# Coupling Attenuation

## SPE-I link segment

# Status coupling attenuation D 2.3

**Table 146–6—Coupling attenuation**

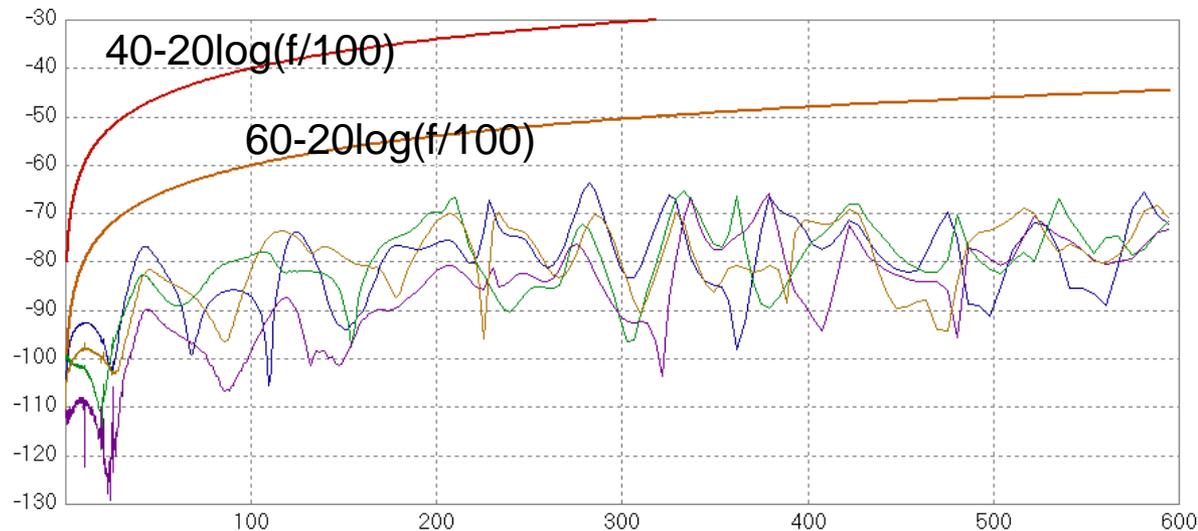
- IEC TC46 decided not to pursue the work in a cable standard but in a measurement standard.
- IEC 62153-4-9Ed2Amd1: Coupling attenuation of screened balanced cables, triaxial method
- The amendment will specify the setup to measure frequencies below 1 MHz.

- 
- The values in actual table 146-7 are the limits at 100 MHz (as in 802.3bp). The frequency dependency is not shown.
  - The slope towards lower frequencies is confirmed to be 20 dB/decade (as it is for higher frequencies).
  - Example of a measurement was shown last time, but from a very high performance cable
  - Due to the very high values a measurement plateau of 85 dB is proposed.
